North Dakota Department of Transportation

ADDENDUM 1 – JOB 2

TO: All prospective bidders on projects SOIA-7-085(096)192, Job No. 2 scheduled for the May 22, 2014 bid opening.

SRF No. 7594

5/12/2014 1:32:12 PM dkieffer H:\Projects\7594\70085192.096\Design\Addendum A\Plan\200XS_078-85_103-107_US_Hwy_85_AD-A.dgn

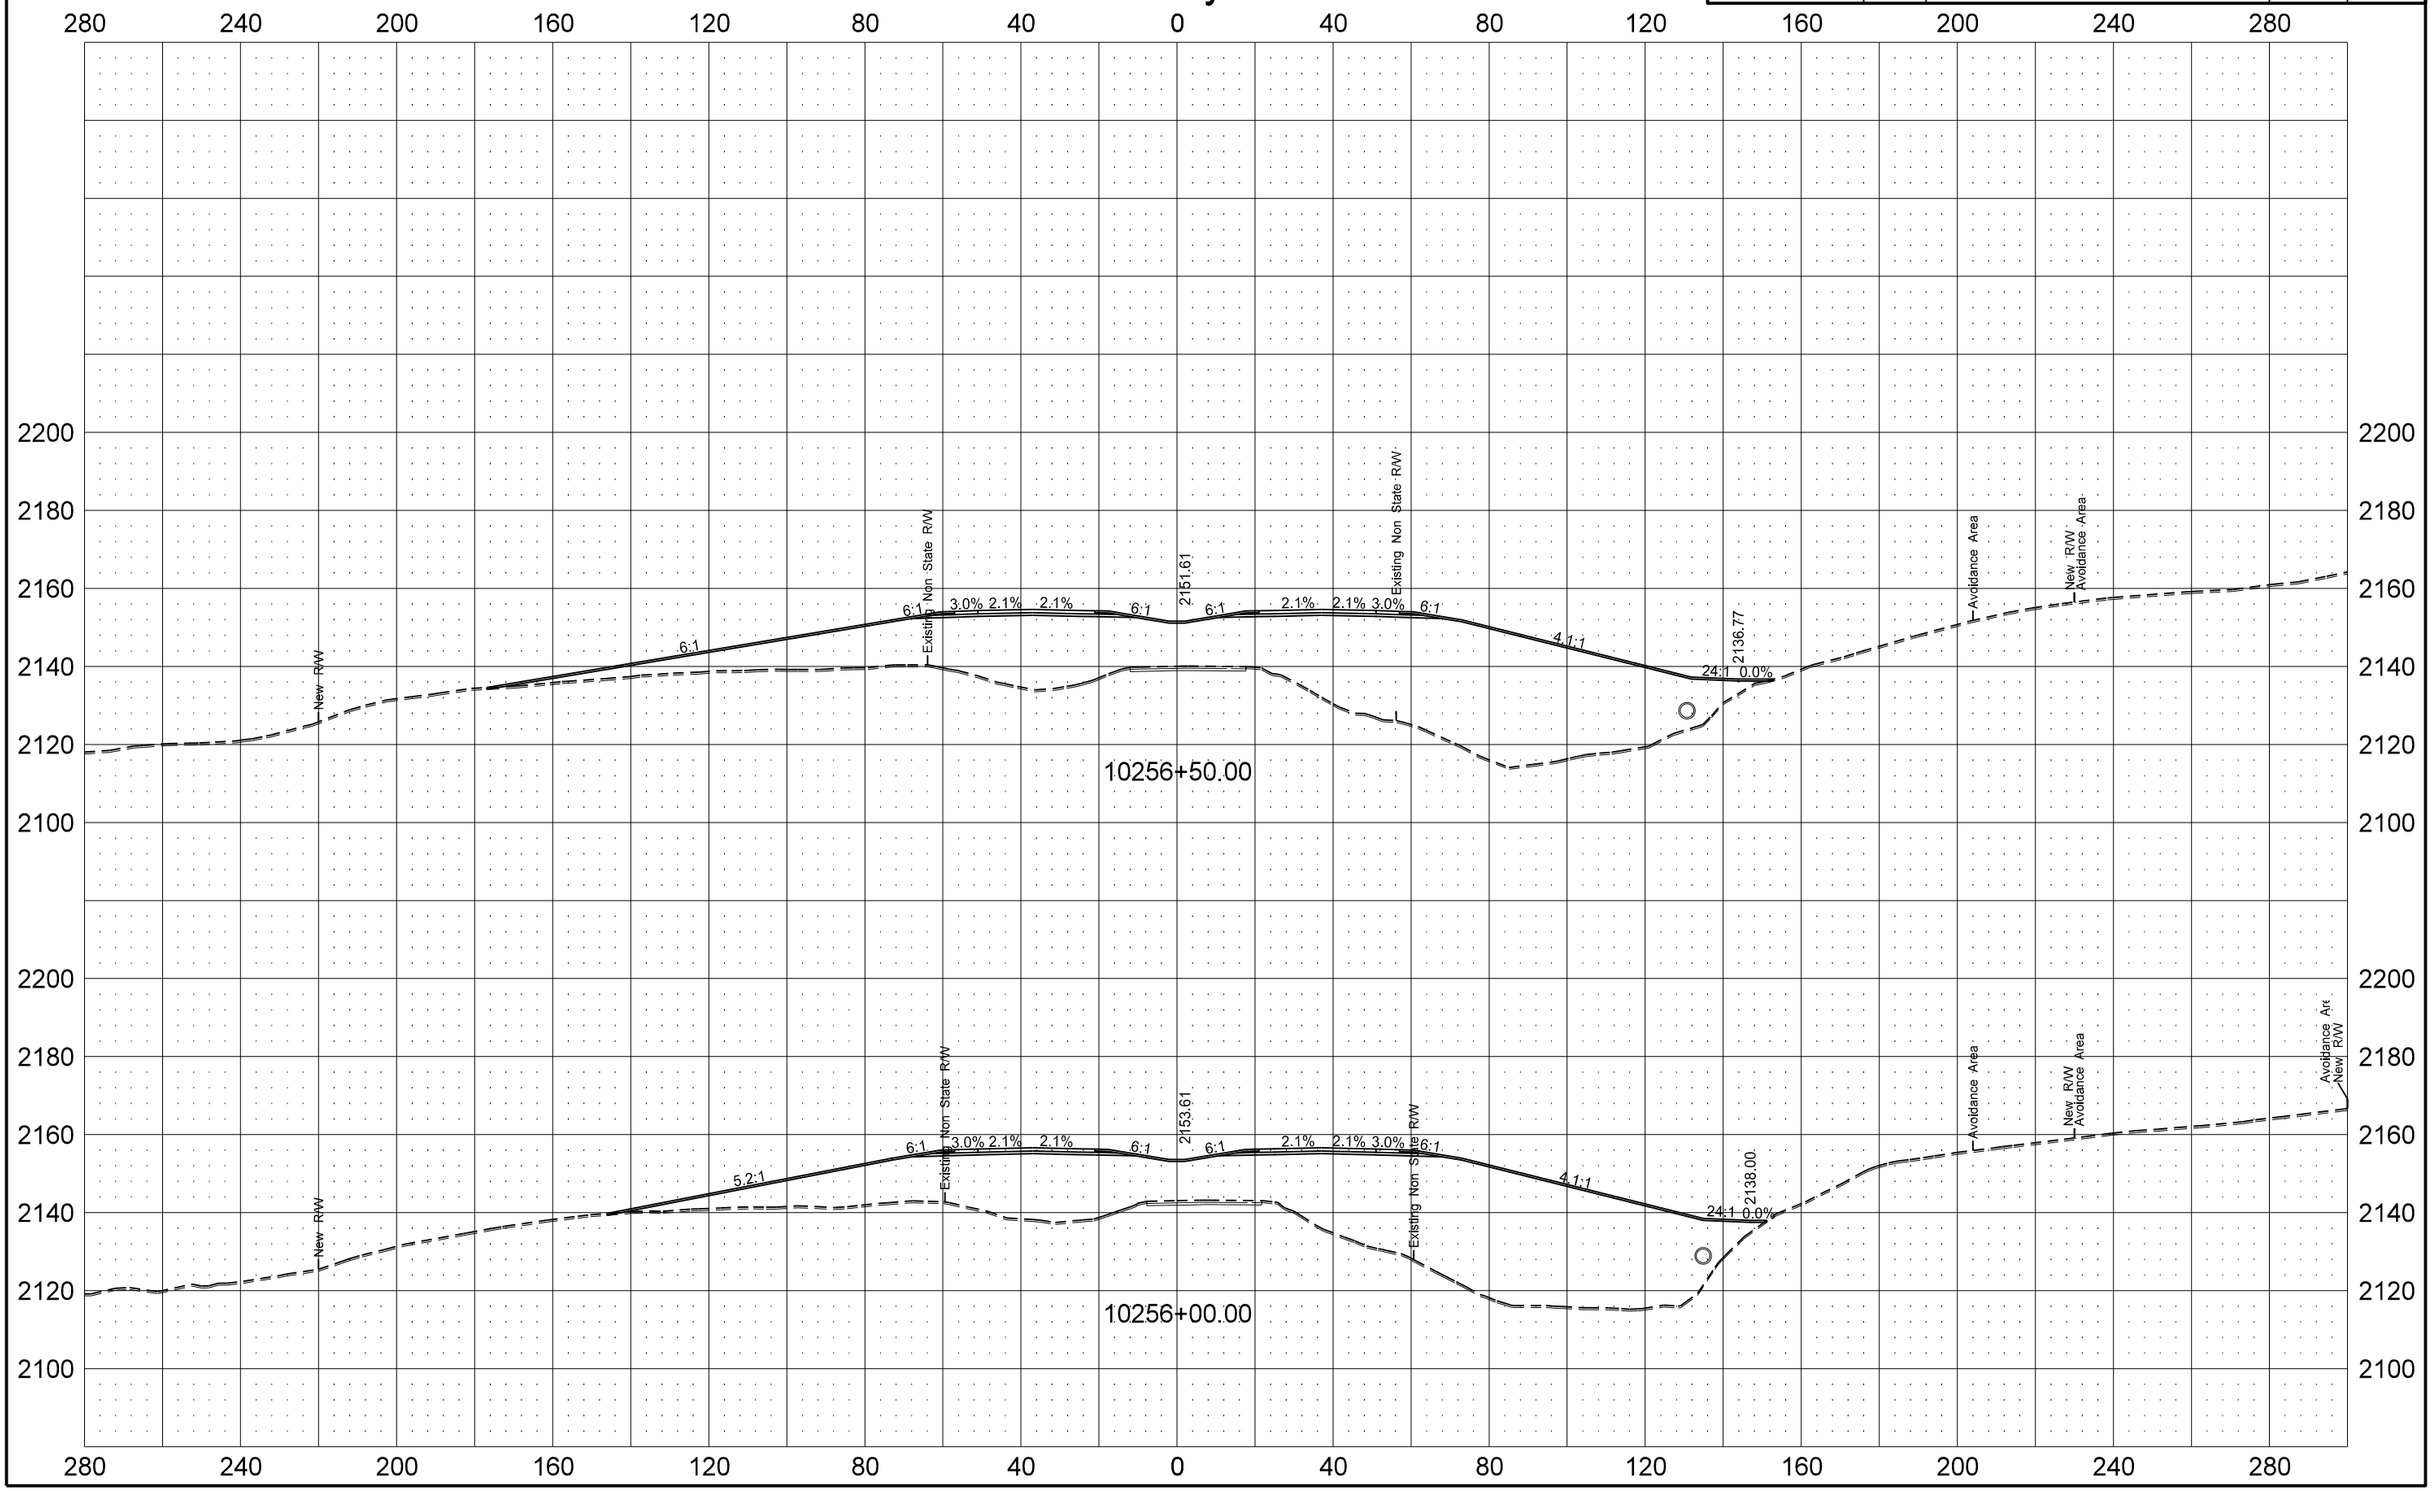
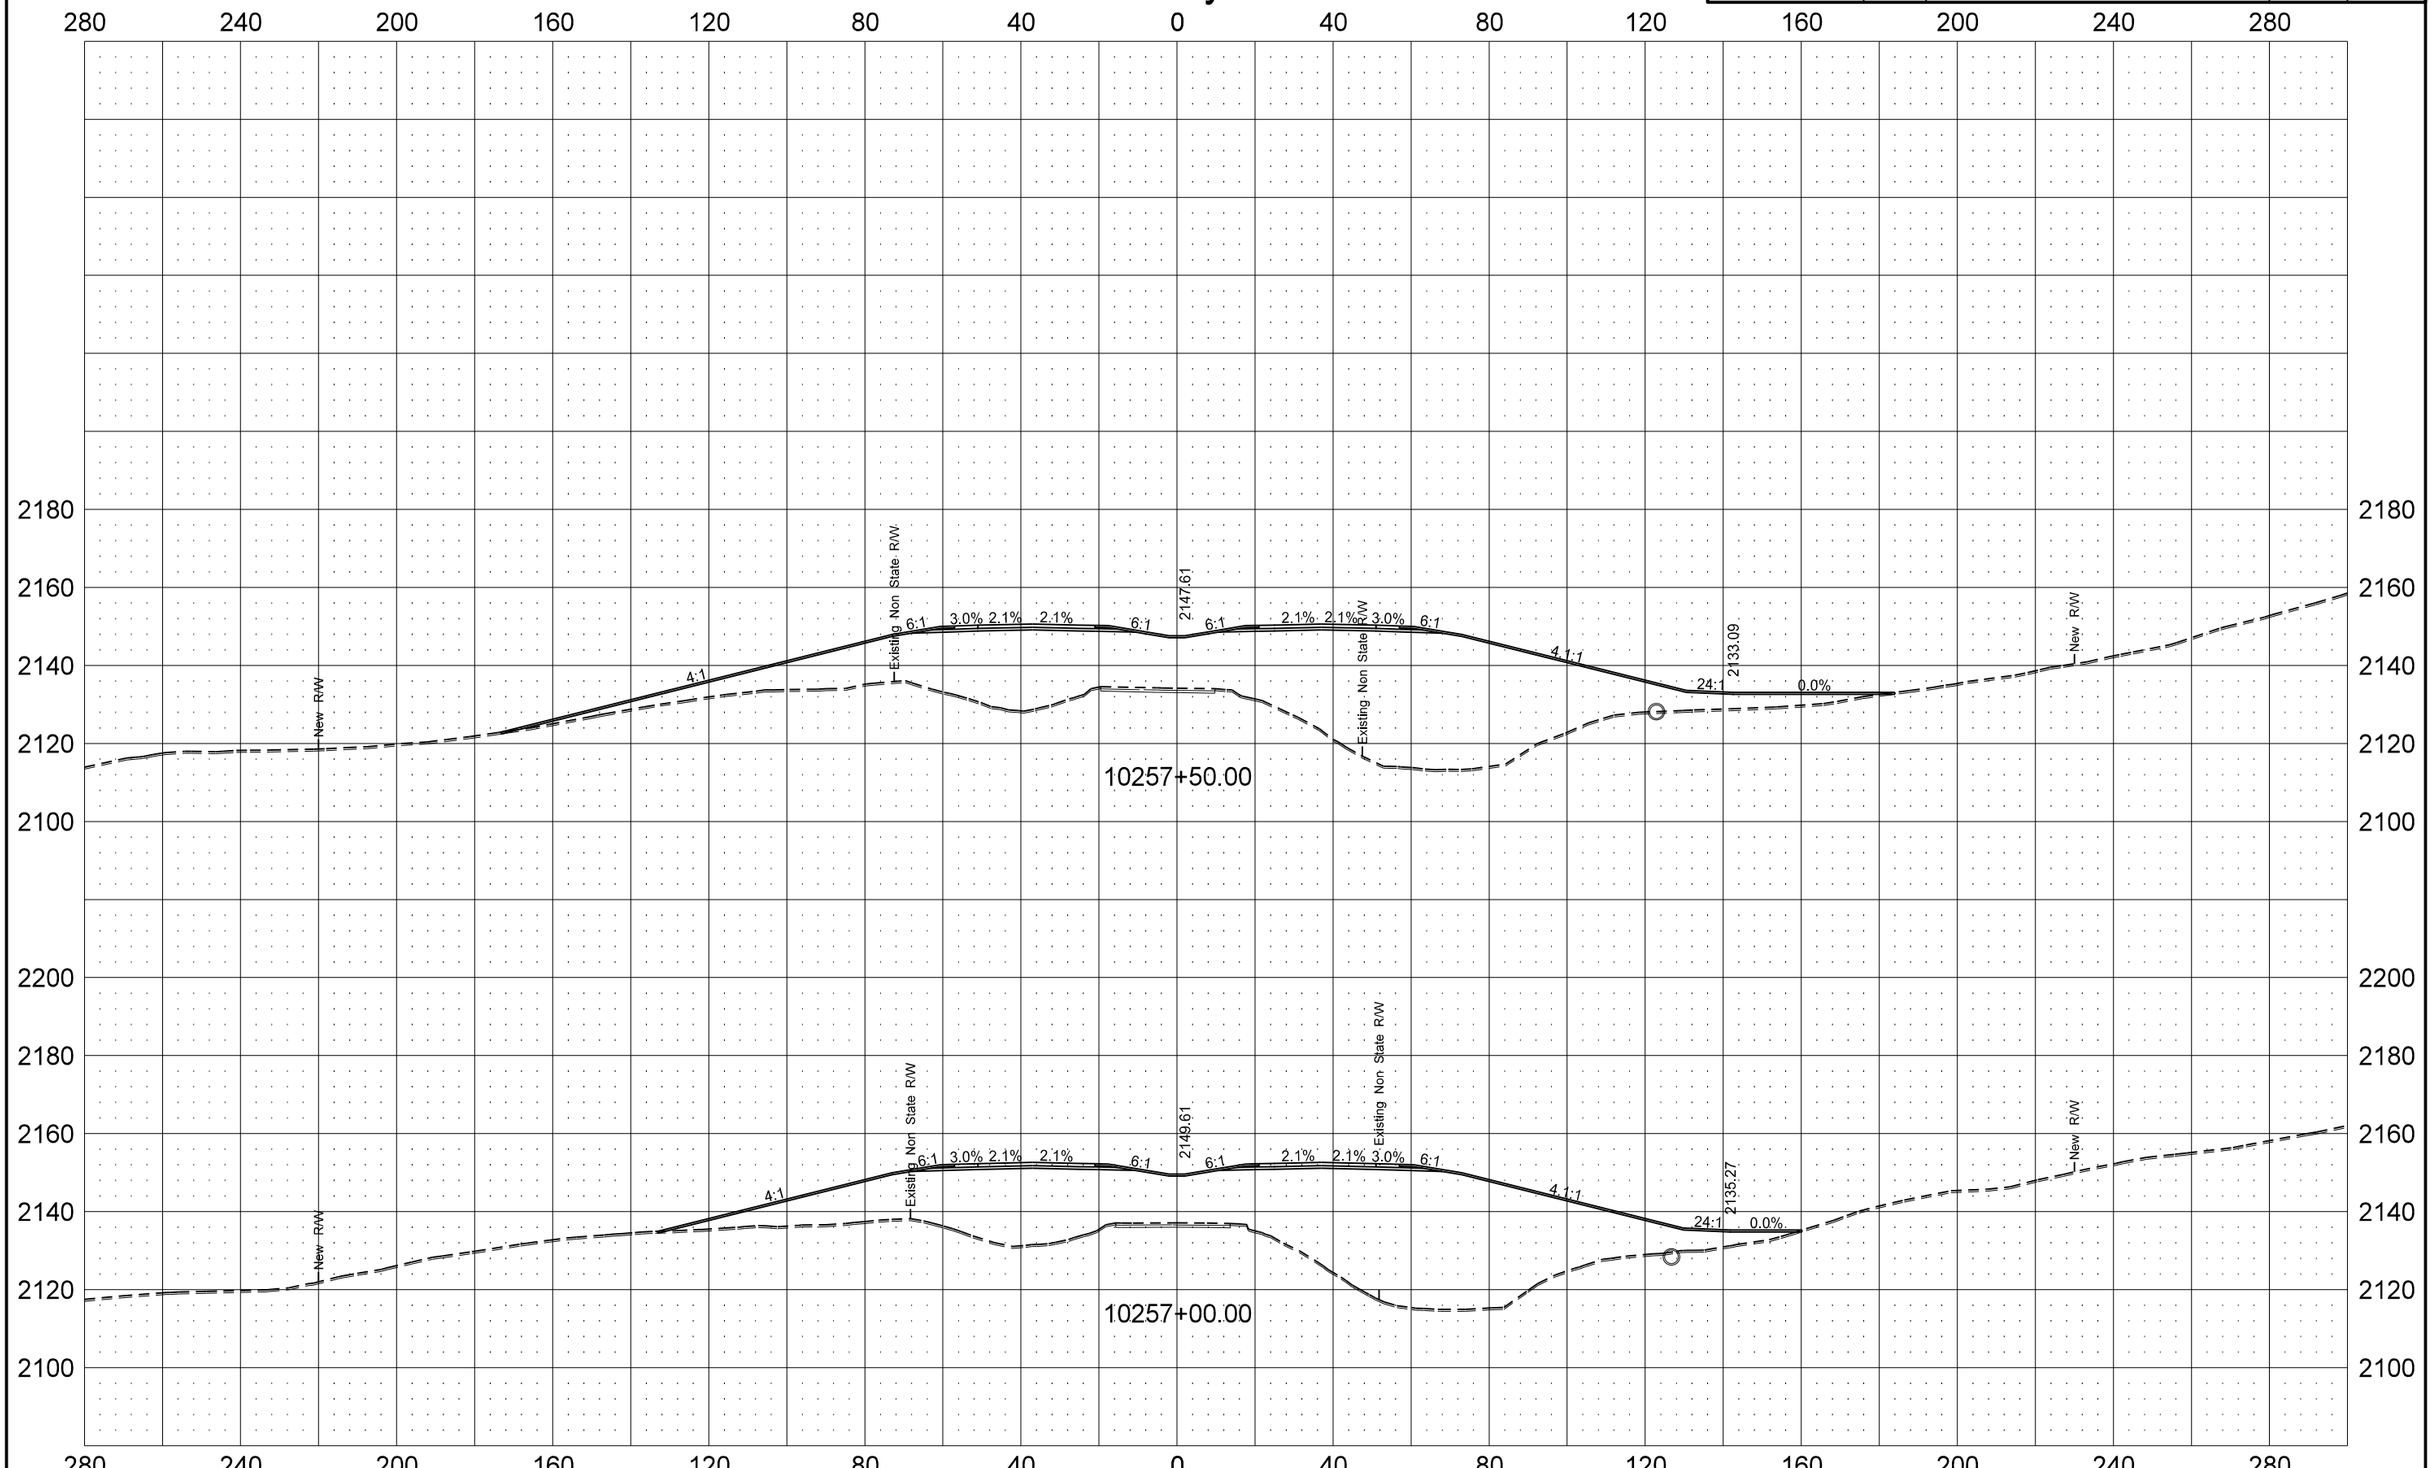
Sheets 200-78 through 200-107:
Revised cross sections due to change in retaining wall.
